SERVICE LETTER NUMBER 125			
TITLE: BOW BULKHEADS, LOWER FLANGE REINFORCEMENT			
BY: K. TAYLOR	AIRCRAFT MAKE/MODEL(S):	FLOAT MODEL(S):	NOTE(S):
APP: R. ADLER	CESSNA 208, CARAVAN VIKING DHC-3, OTTER	8000S AND 8000A	OPTIONAL COMPLIANCE
DATE: 26-SEP-11			S/L P/N 1005509
REV: A			ECO 22250

MAT'L 2024-T3 DOUBLERS ON 6061-T6 BULKHEAD		WIPAIRE, INC. 1700 HENRY AVE. SOUTH ST. PAUL, MN 55075 (651) 451-1205				
FINISH N/A					TITLE MODEL 8000A/S, BOW BULKHEADS 11 TO 16, LOWER FLANGE REINFORCEMENT	
ALL DIMS IN INCHES & AFTER FINISH	THIRD ANGLE PROJECTION 	TOLERANCES .X= ±.05 .XX= ±.015 .XXX= ±.005 X' = ±.5'	SIZE B	SCALE NTS	PART NO. 1005526	REV A
		Sheet 1 of 1

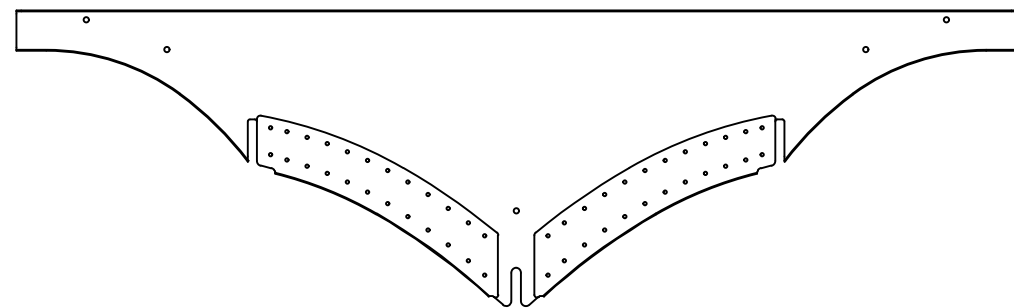
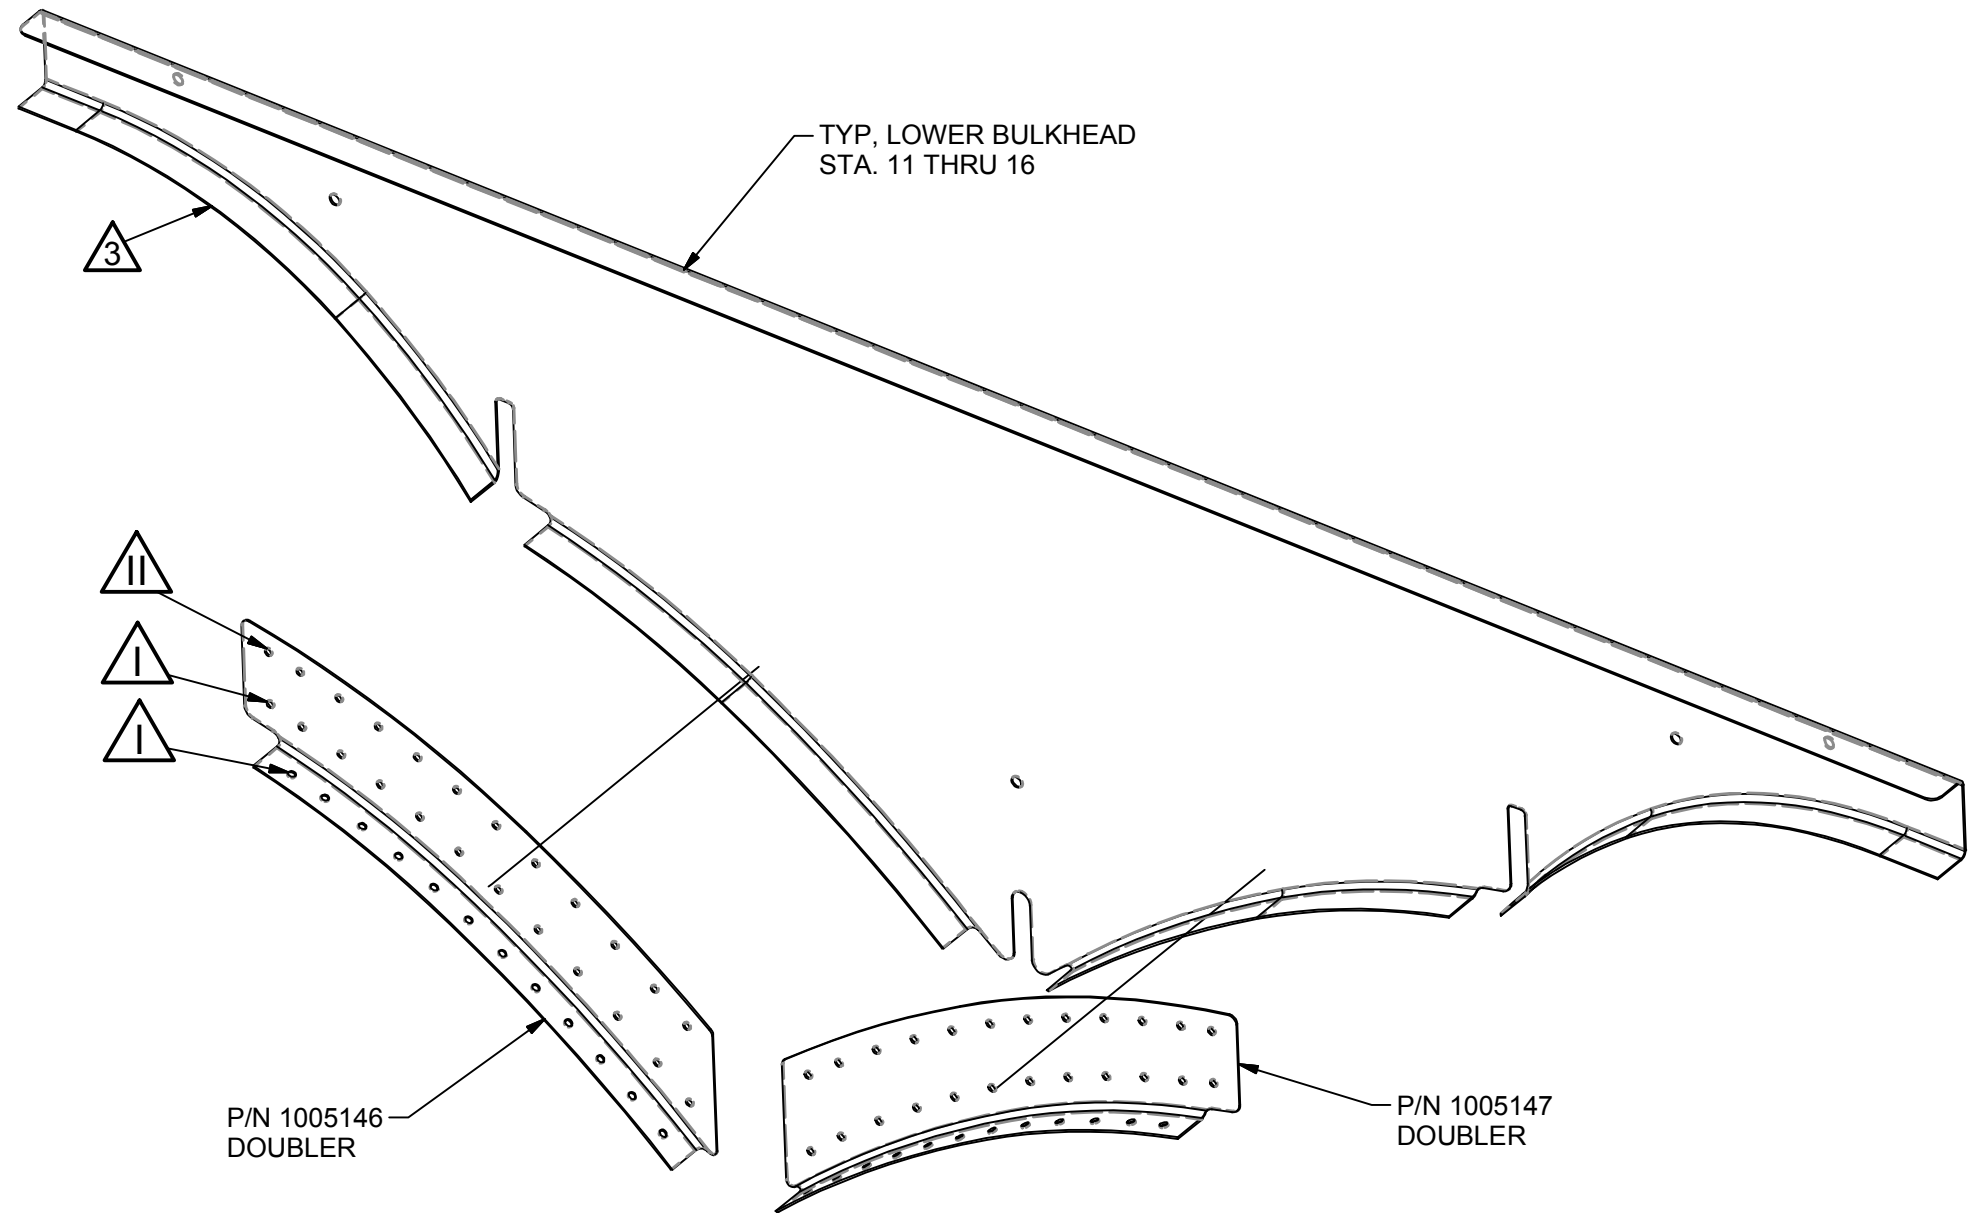
Certain aircraft operated in rough water regularly may experience cracking of the lower bulkhead flanges on the bow area of the float. This service letter and associated kit reinforce the lower bulkhead flanges of the bow bulkheads to assist in load transfer and reduce probability of cracking as a result of operations on rough water.

To accomplish this modification: Install doublers P/N 1005147 and 1005146 on the lower bow bulkhead flanges at stations 11 thru 16 in accordance with drawing 1005526 latest revision. Drawing 1005526 is attached to this service letter.

2. THIS DRAWING SPECIFIES REINFORCEMENT OF THE LOWER FLANGE OF BULKHEADS 11 THRU 16 ON MODEL 8000 FLOATS.

B. POSITION AND MATCH DRILL DOUBLERS AT EACH LOWER BULKHEAD FLANGE, AFTER DRILLING INTERFERING RIVETS:.

I. MATCH DRILL THESE ROWS OF RIVETS TO EXISTING RIVETS IN LOWER FLANGE AND BULKHEAD FACE.

II. ADD THIS ROW OF RIVETS AT 0.5 EDGE DISTANCE ON UPPER DOUBLER FLANGE, MATCH SPACING ON LOWER FLANGE.

C. ONE DOUBLER AT A TIME; APPLY SEALANT COMPLETELY TO MATING FACES OF DOUBLER, BULKHEAD, AND BOTTOM SKIN. THEN RIVET DOUBLERS 1005147 AND 1005146 TO LOWER BULKHEAD FLANGE AND BOTTOM SKIN USING MS20470AD4-4 RIVETS. PERFORM THIS OPERATION AT BOW BULKHEADS FROM STATIONS 11 TO 16. DRIVE RIVETS WHILE SEALANT IS WET. RIVET LENGTH MAY BE VARIED ONE DASH NUMBER AS REQUIRED.
